Earthworks

You said: “Sensitive land shaping must take precedence over long-term planting programmes.”

Site plan - Noise mitigation earthworks

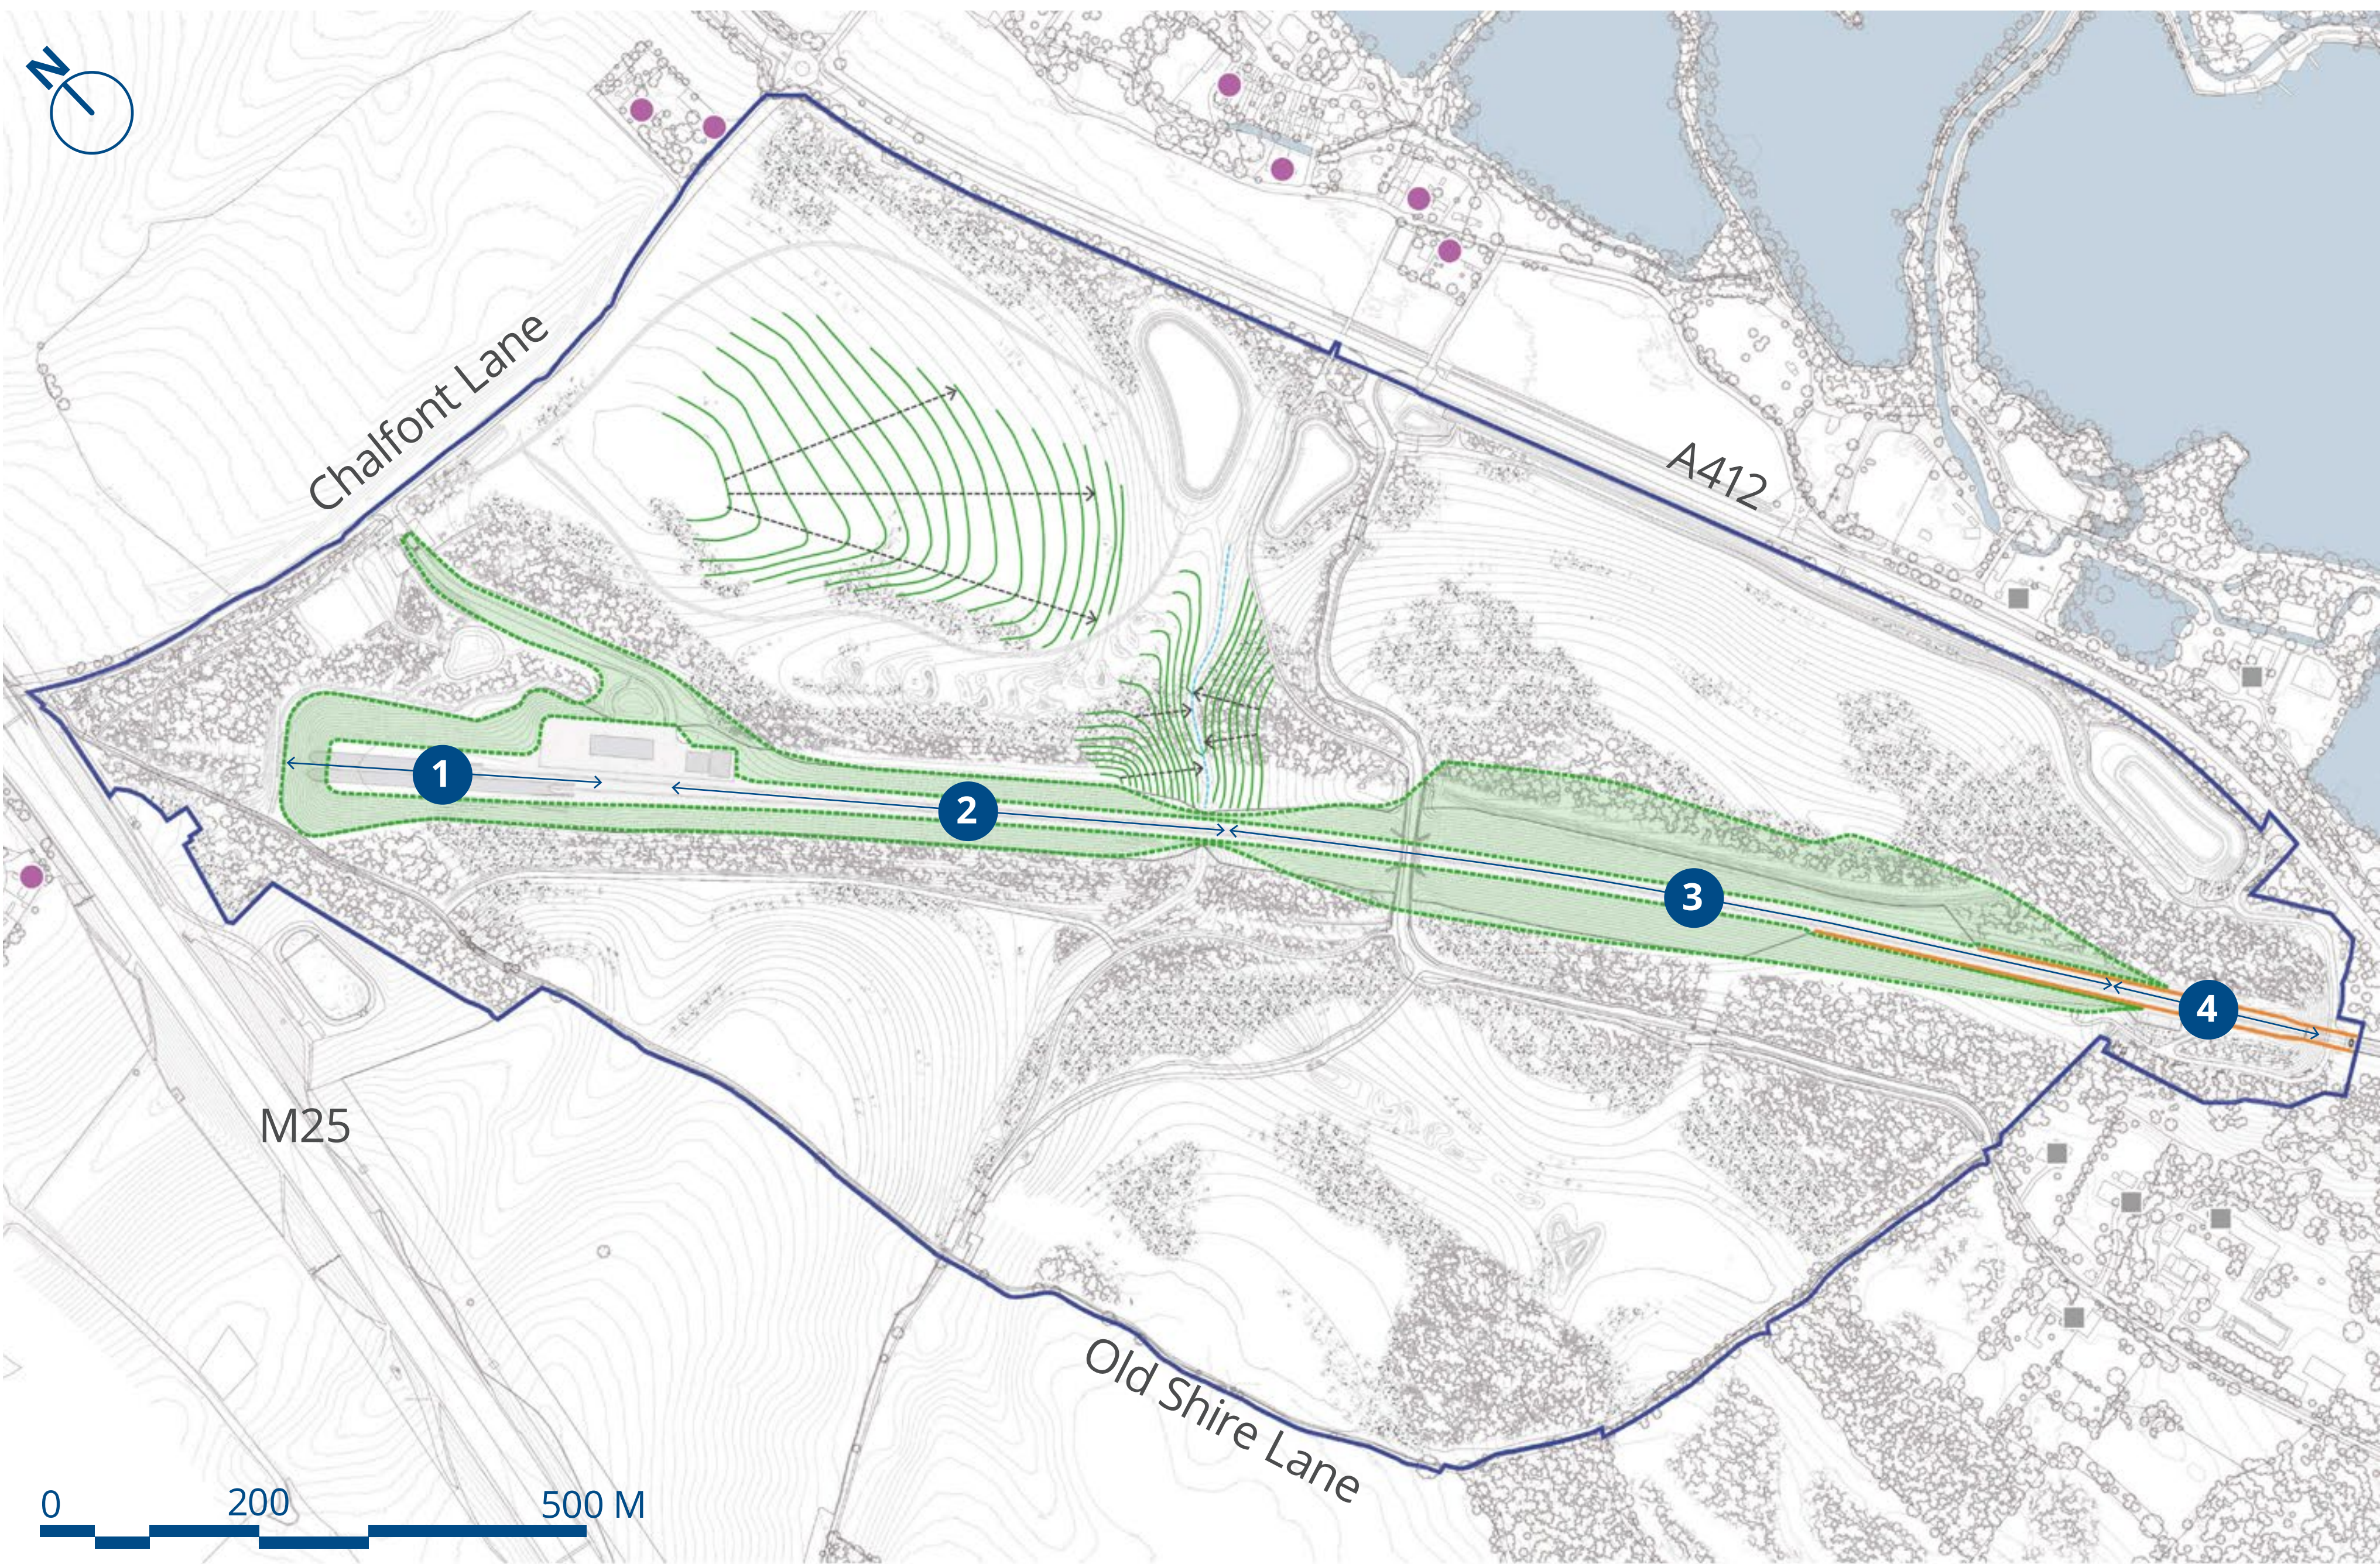
You said: “Any land shaping should be done to minimise noise impacts as well as visual ones.”

Design earthworks to mitigate noise impacts

Our earthworks are designed to provide a barrier to operational noise. This will reduce the effect of the noise caused by the railway on the receptors identified in the Environmental Statement. We are also creating noise attenuation barriers along the Colne Valley Viaduct North Embankment as illustrated.

Noise assessment modelling has been used to achieve the best combination of acoustic screening performance whilst being sympathetic to the other aims of the landscape design.
